DELHI DEVELOPMENT AUTHORITY
(MASTER PLAN SECTION)

Minutes of the 90th. Technical Committee meeting held on 30.6.98 at 10.00 A.M. in conference Hall, 5th. Floor, Vikas Minar, I.P.Estate, New Delhi.

Draft minutes of the 90th. Technical Committee meeting held on 30.6.98 at 10.00 A.M. in conference Hall, 5th. Floor, Vikas Minar, I.P.Estate, New Delhi.

The 90th Technical Committee meeting of the DDA will be held on 30.6.98 at 10.00 A.M. in the Conference Hall, 5th floor, Vikas Minar, IP Estate, New Delhi.

PROPOSED ROUTE FOR LAYING 2 NOS 33 KV CABLES FROM EXISTING 33 KV S/STN AT KARKAR DOOMA TO PROPOSED 33KV STN AT KRISHNA NAGAR NEAR POLICE QUARTERS.

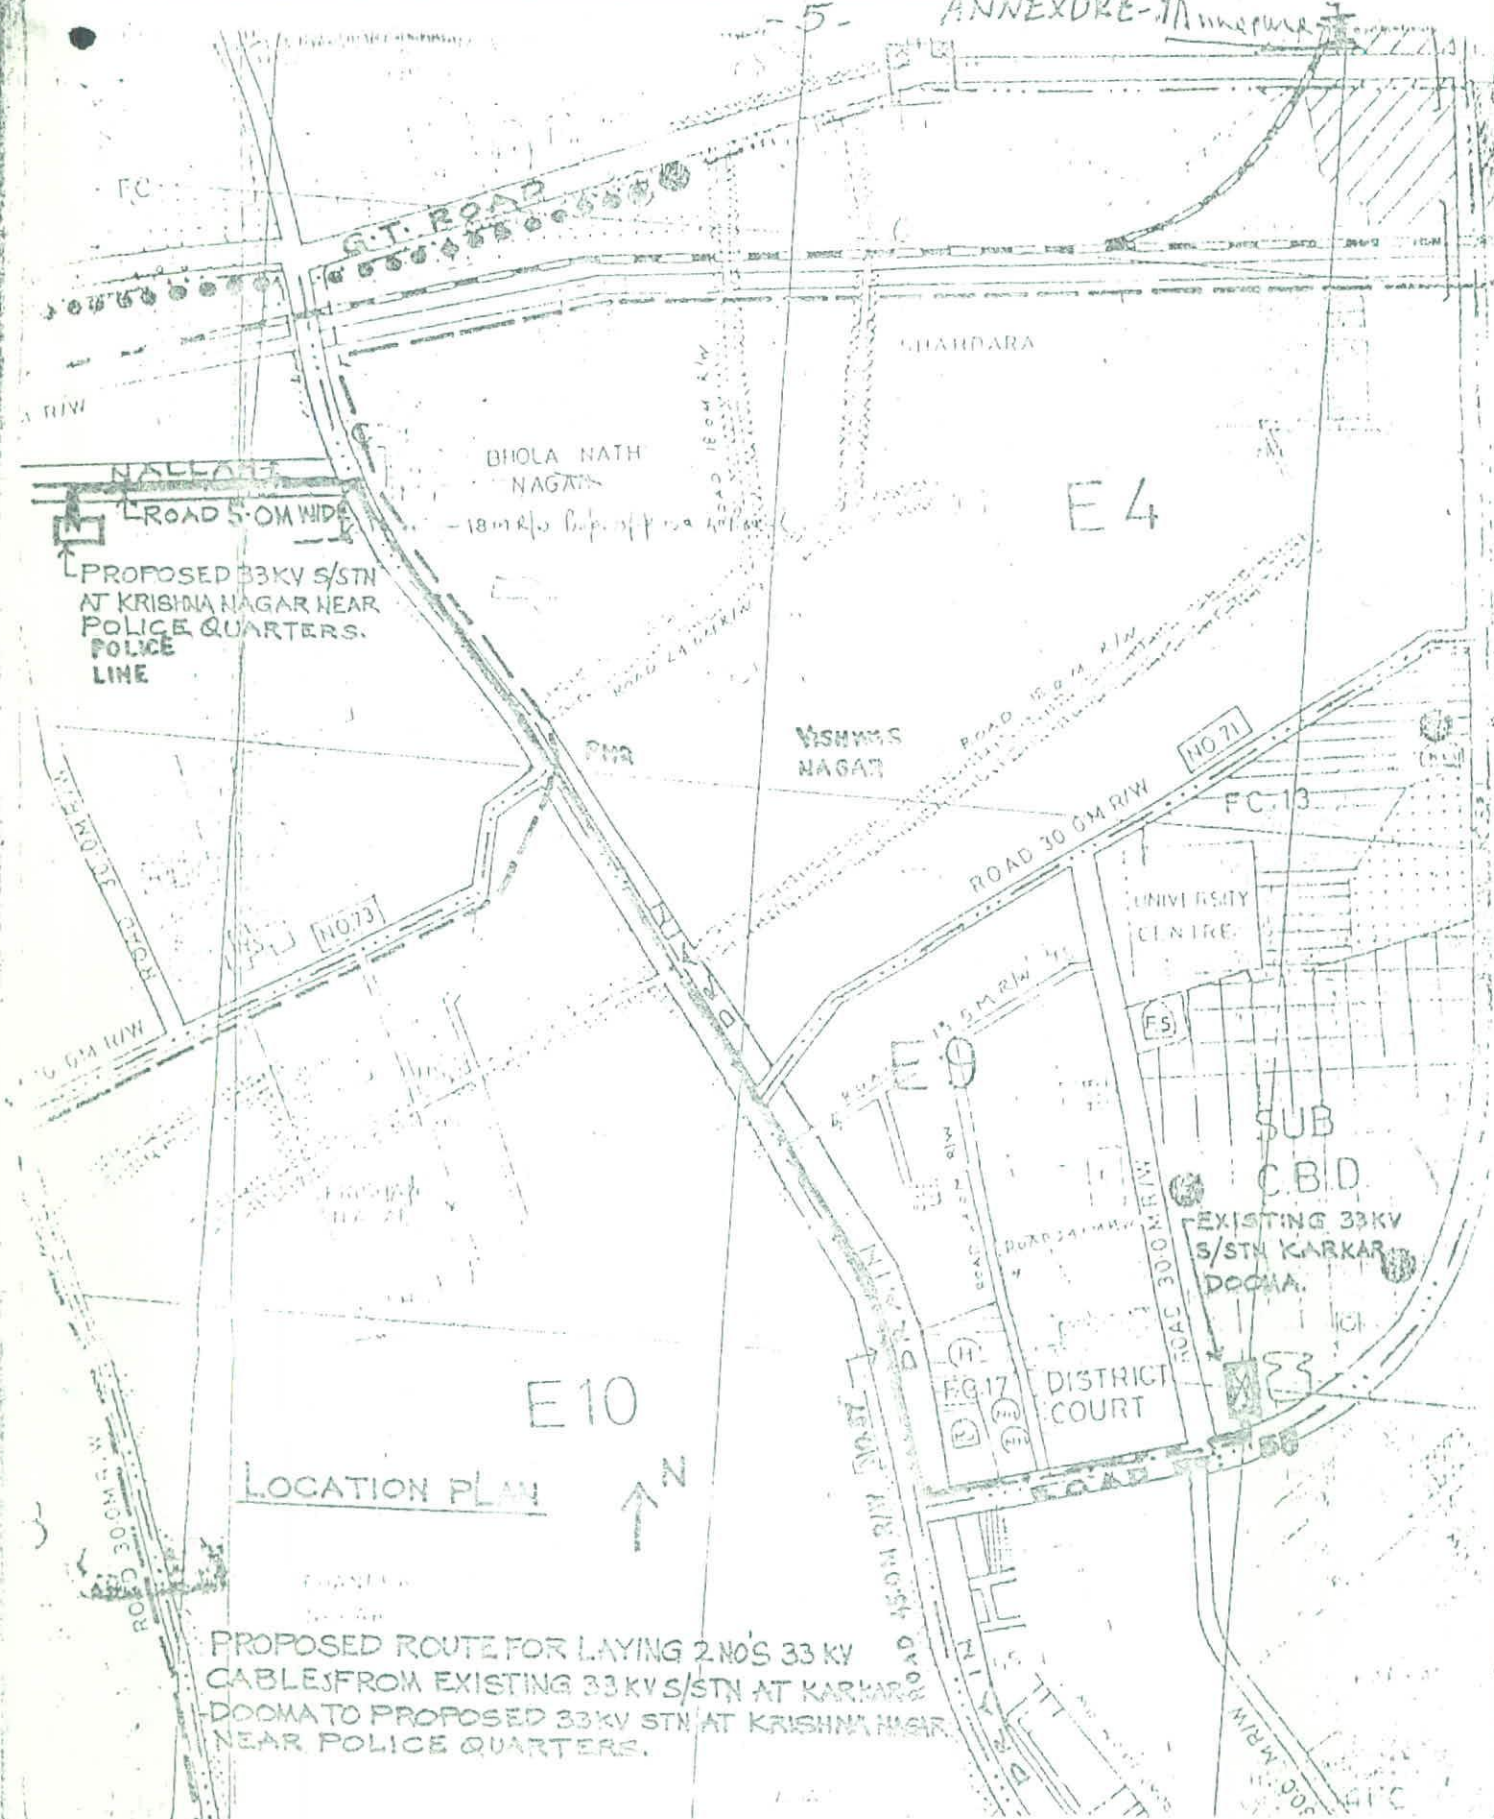
3.1 As per the Master Plan and Zonal Plan the right of way of the road No. 58 is 45 M. But the available R/W is 57 M. at this specific location. The alignment plan of this road stretch has not been prepared/approved by the DDA. The cables be laid at a distance of 22.8 M from the centre of the existing

Central verge as per section(AA) on the Northern side of the road.

3.2 As per the Master Plan and Zonal Plan the R/W of the Road no. 57 is 45 M. The alignment plan of this road has not been approved by the DDA. The cables be laid in the eastern footpath at a distance of 13.5 M from the centre of the existing centre verge.

3.3 As per the plan prepared and approved by the DDA for the site of Police Line, as approach road of 18 M R/W has been proposed for providing the entry to the Police Lines the route be taken from this road but this road has been encroached and is sub-judice.

3.4 The route has been proposed below the carriageway by DVB on the 5 M road adjoining the Drain at a distance of 1 M from the boundary wall of the Nala/ Drain is not desirable due to less R/W of the road and has been proposed to be taken under the main carriageway of the road.

The route proposed by DVB in para 2.0 above with the suggested modifications of the route by DDA in Para 3 above is proposed for consideration and approval.

LOCATION PLAN
 PROPOSED 220 KV U/G CABLES FROM TOWER N.11
 OF 220 KV TOWER LINE TO PROPOSED 33/11 KV S/ST
 DWARKA PURI (SHANDARA)

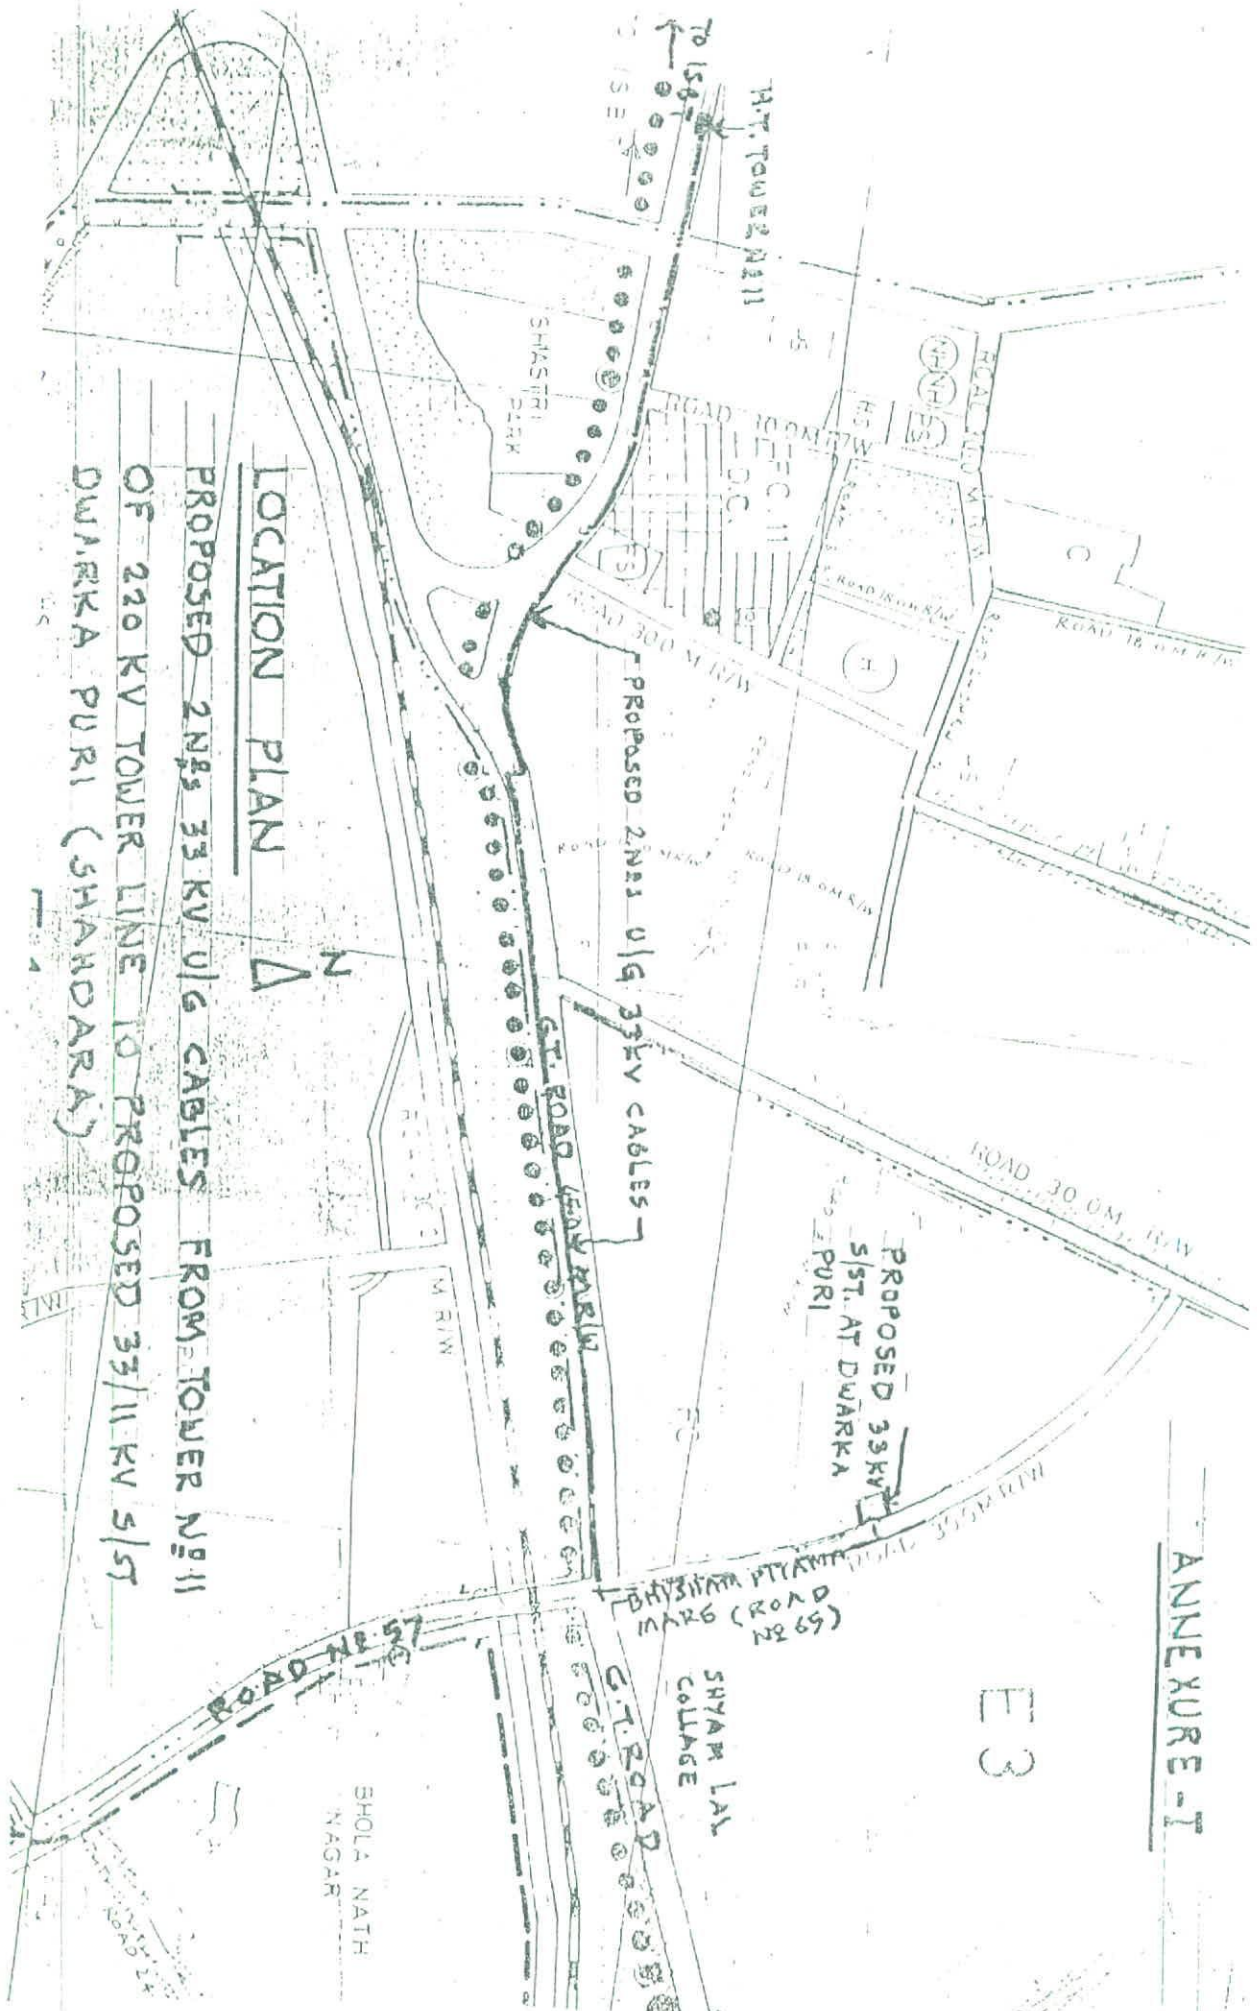
The R/W of the approach road to ISBT is 60 m and the cables has been proposed below the Northern foot path at a distance of 16.5m from the existing centre verge is acceptable.

- 3.2 The route could not be proposed along the Northern foot path of G.T. Shahdara road as number of under ground cables are existing as informed by officer of DVB.

However, as per the approved plan of G.T. Shahdara Road prepared by NATPAC for MCD (Approved by Authority on dt. 1.12.92 vide item No.151/92) the cable provision has been made under the proposed Southern Foot path at a distance of 16 metre from the existing Centre of the central verge up to the junction with Bhisham Pitamah Marg. Where as DVB proposed the cable at 13.75 M/14M which is not acceptable to DDA. Therefore it is proposed that this should be proposed at 16.0 M from the centre of the central verge under the foot path.

- 3.3 As per the MPD-2001 the r/w of the Bhisham pitamah road is 45 m where as in the Zonal plan of Zone 'E' this has been shown as 30m. An alignment plan of the road was approved by the DDA on dt. 4.12.75 vide item No.118 with a r/w of 45 m. It is now recommended by us that this cables may be laid on the western side of the road with in the r/w at a distance of 8.5 m. from the western edge of the r/w line along with the other two under ground electricity cables.

The route proposed by DVB as explained in para 2 above and the modifications proposed in para 3 above is placed before the Tech. Committee for Consideration and approval.
